# **Closeout Report**

Technical, Cost, Schedule, and  
Management Review

# **TEVATRON RUN II LUMINOSITY UPGRADES**

February 26, 2004

# Design and Base Projections

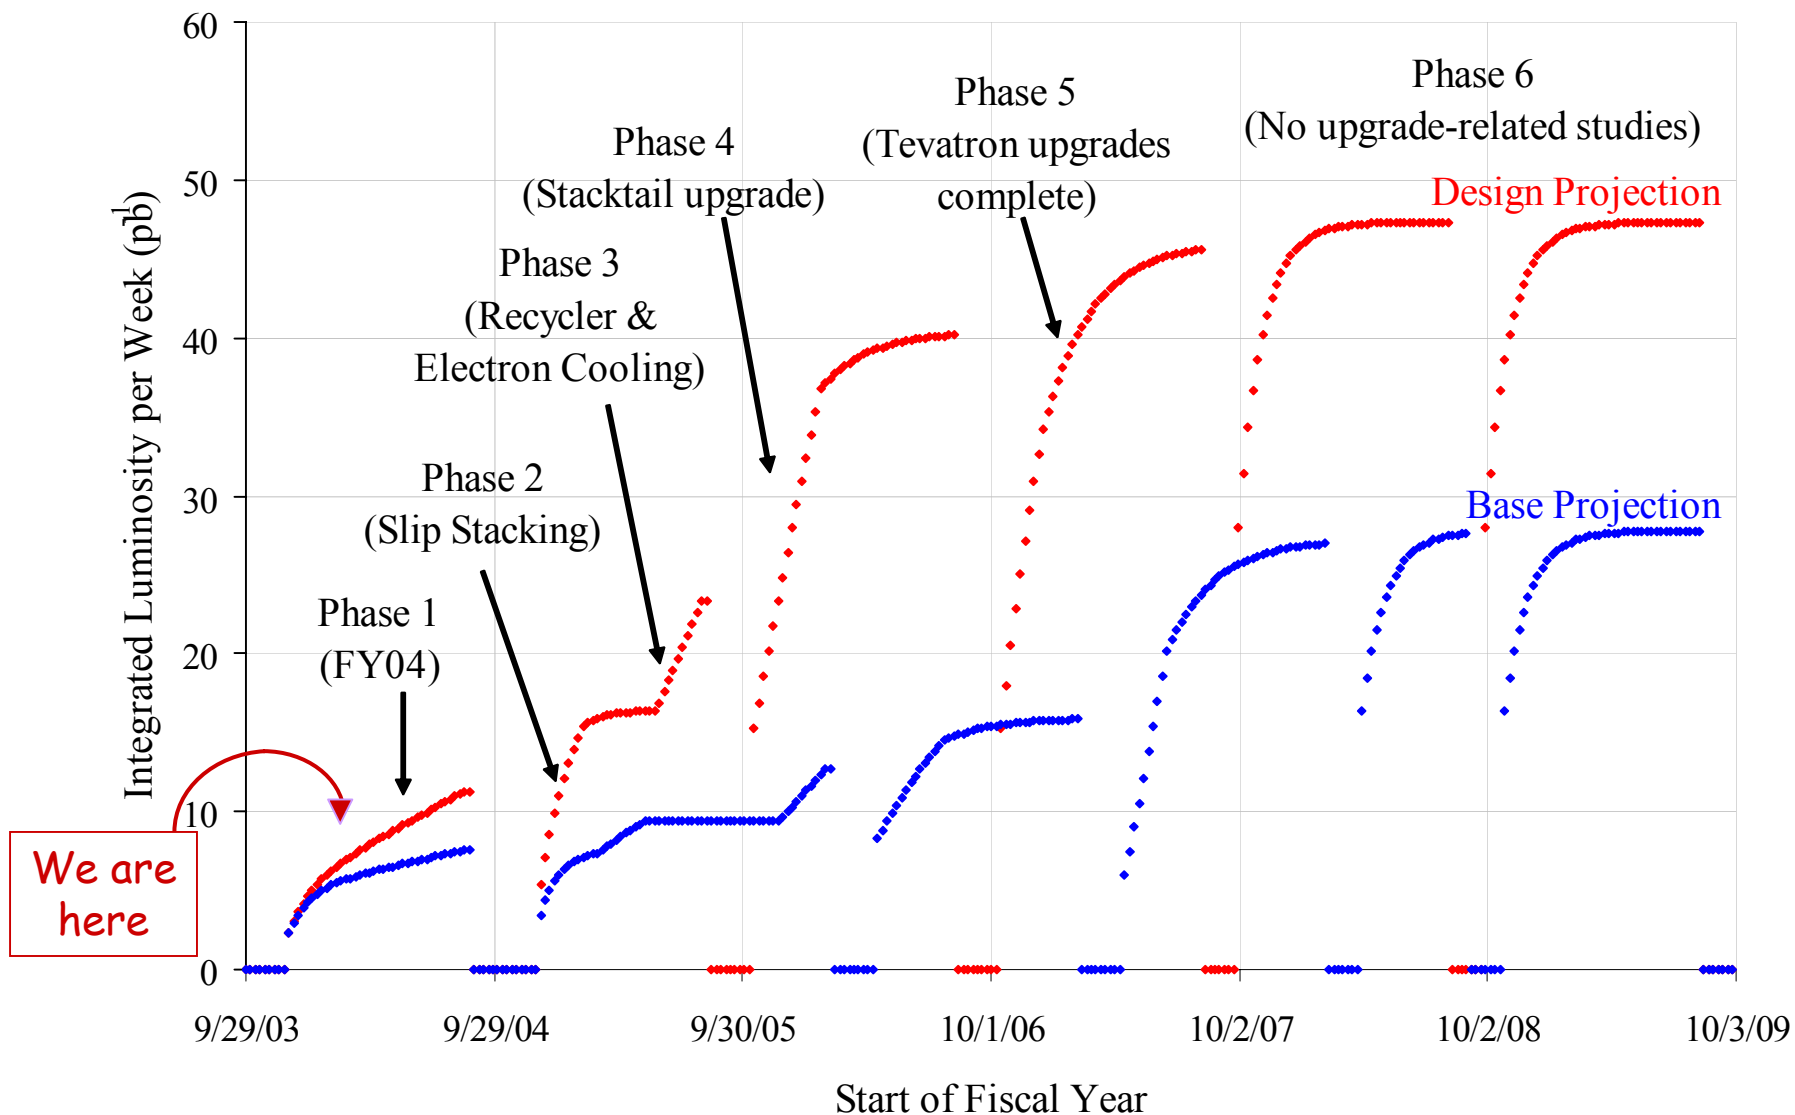
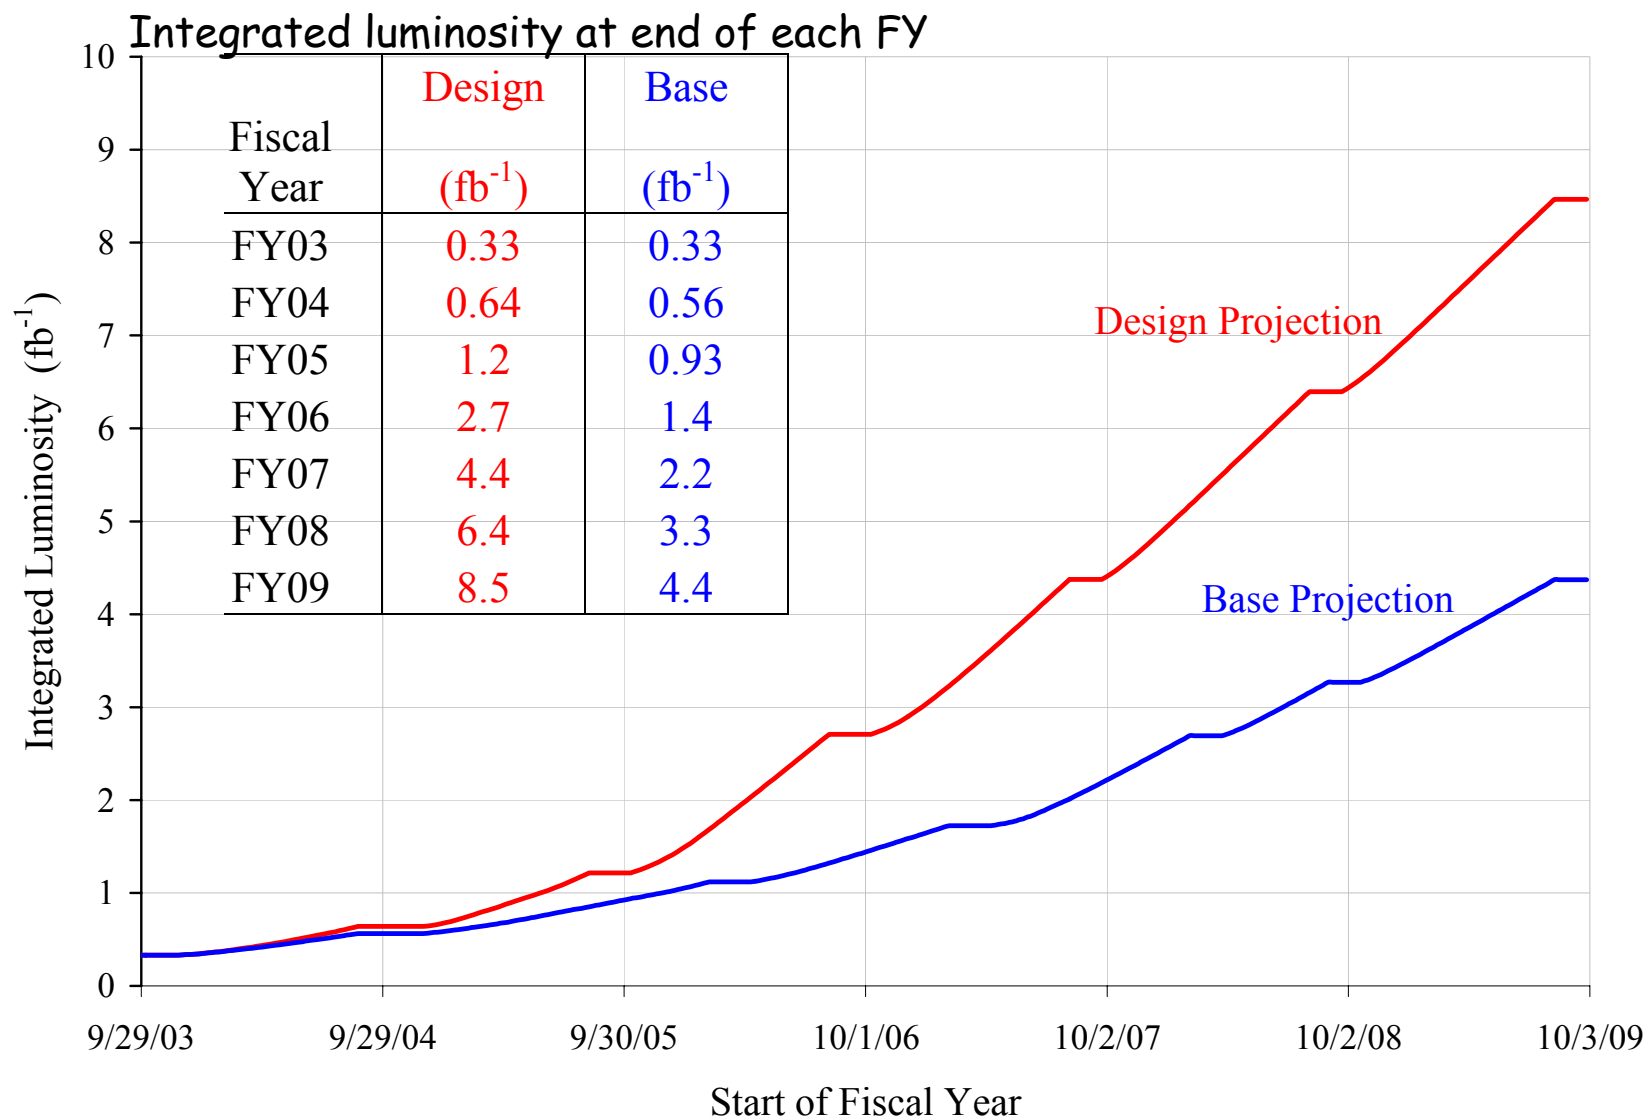
**The Laboratory has presented two projections of the luminosity through FY09, a “design” projection of 8.5 fb<sup>-1</sup> and a “base” projection of 4.4 fb<sup>-1</sup>.**

**The “design” projection assumes timely success with the stack-tail cooling upgrade, antiproton stacking rates, beam-beam performance in the Tevatron and electron cooling in the recycler. Although very good progress has been made, there is still significant uncertainty.**

**The “base” projection could be reached without the stack-tail cooling upgrade or electron cooling if there is no schedule slip in other upgrade activities and if their performance goals are met.**

**Because of progress on Run II upgrade activities since the last review, the committee now views the base goal of 4.4 fb<sup>-1</sup> by the end of FY09 as having a good probability of being met or even exceeded.**

**Meeting the design goal of 8.5 fb<sup>-1</sup> by the end of FY09 remains a very challenging goal.**
